DESIGN RECOMMENDATION - 212 18TH AVE - # 3023583

DESIGN RECOMMENDATION - 208 18TH AVE - # 3023584

DESIGN RECOMMENDATION - 1804 E SPRUCE ST - # 3023032

1804 E. Spruce Street
August 9, 2017, 8:00 pm

E D G 2 BOARD COMMENTS

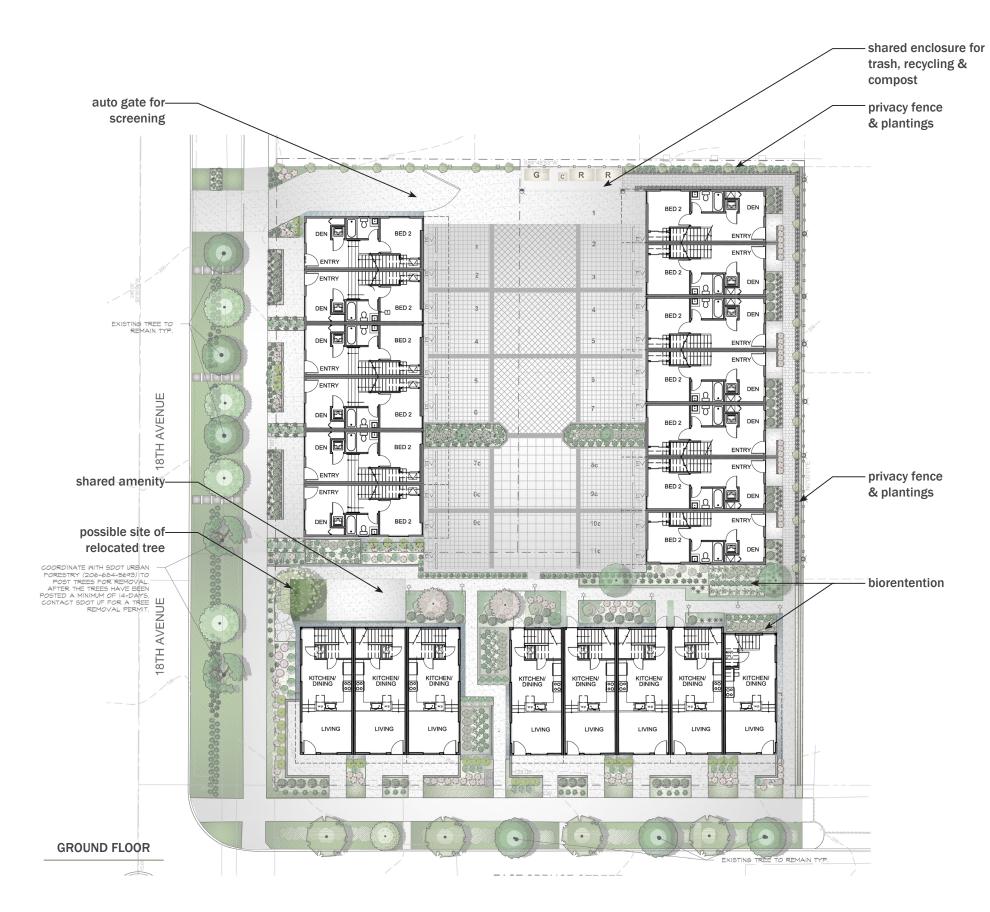
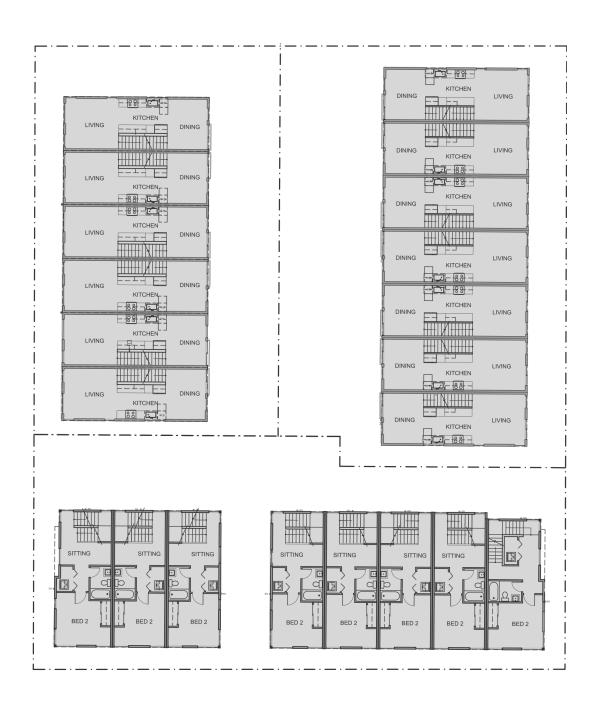
- Design should include high-quality, long lasting materials rooted in local precedents.
- Bricks should play a larger role and less quantity of different materials but higher quality material should be applied consistently.
 - The design team has since updated the street-facing elevations using high quality brick to wrap around the building edges where used.

- Clarity of programming for the courtyard and the amenity area should be reinforced.
 - Distinct pavement treatment has been given to the parking court and separated from the amenity area.
 - Landscape design provides buffers to clarify programming and transition between public and private realms.

- Balconies should be considered to provide those units without direct access to the amenity space area with some private open space opportunities
 - Juliette balconies will be provided to give interaction with the amenity space that gives privacy as well as open space to those units that do not have direct access.

- More renderings and detail will be needed to show the buffer between amenity area and Boys & Girls Club.
 - A new rendering has been added to the packet to show the continuous landscape buffer.
 - A tree has been proposed at the east edge of the amenity area to further buffer views.

- A continuous landscape buffer should be included that screens the driveway and the trash area at the northern project edge.
 - The landscape design team has since updated their plans to provide a continuous landscape buffer at the northern project edge.

- Trash should be grouped together and screened from surrounding uses.
 - A new trash location has been submitted to SPU for approval

EXCEPTIONAL TREE: ANALYSIS

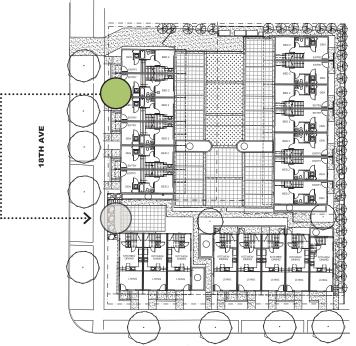
A Japanese maple at the west side of the site on 18th Ave satisfies the City of Seattle minimum threshold diameter to be considered an exceptional tree. As stated in the City of Seattle Director's Rule 16-2008, all exceptional trees are required to be retained through development and protected with limited impacts within their dripline.

Protecting the existing exceptional tree would require absolutely no disturbance of the inner root zone, defined as the inner one-half of the area under the tree's outer drip line. Additionally, it has been recommended that not more than 1/3 of the outer one-half of the tree's drip line be disturbed by demolition and construction activity.

It is the opinion of the design team, based on information from City of Seattle codes and professional arborists, that the exceptional tree in question should be removed from the site.

The exceptional Japanese maple tree is rooted against the wall of the existing building, and likely has significant contact with foundations. Retaining this tree would cost significant time in demolition and construction, and would prevent the design team from developing a proposal which best meets Design Guidelines and EDG responses.

Given the damage that will certainly occur during demolition of the existing structure, it was recommend to the design team that this tree is removed prior to demolition of the existing structure.

The design team further suggests that if the exceptional tree should survive its removal, it could be relocated to the amenity area, near the west edge of the site. See graphic below.
